Technical Service Information

THM 440-T4 1-2 SLIP AND/OR SHUDDER

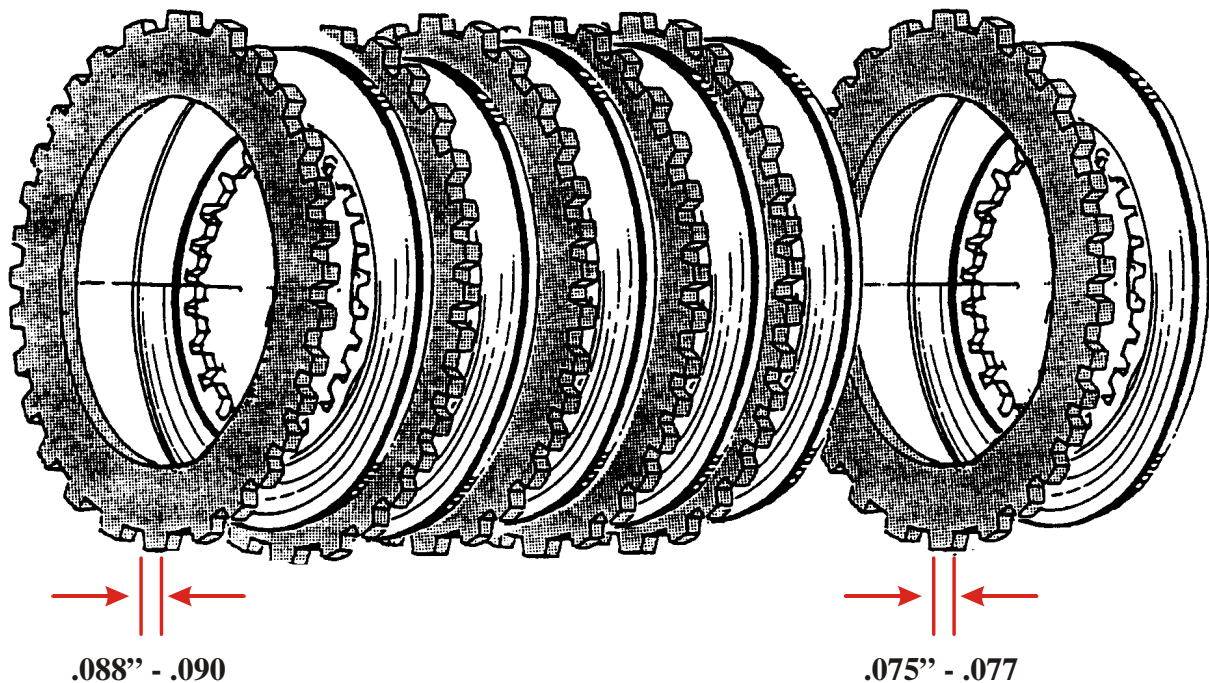
COMPLAINT: 1-2 slide shudder on THM 440-T4, 1984-87.

CAUSE: Can be caused by clutch lining compatability of lined plates. This can also be a problem encountered with SRTA or factory rebuilt units.

CORRECTION: Install kit number 8662913 for 1984 thru 1986, which comes with five (5) lined plates and five (5) steel (koline) plates. The koline plates in this kit are .088-.090 thick. For the 1987 units, use kit number 8662914, which comes with six (6) lined plates and six (6) steel (koline) plates. The koline plates in this kit are .075-.077 thick.

8662913 - (5) CLUTCH KIT - 1984 - 86

8662914 - (6) CLUTCH KIT - 1987
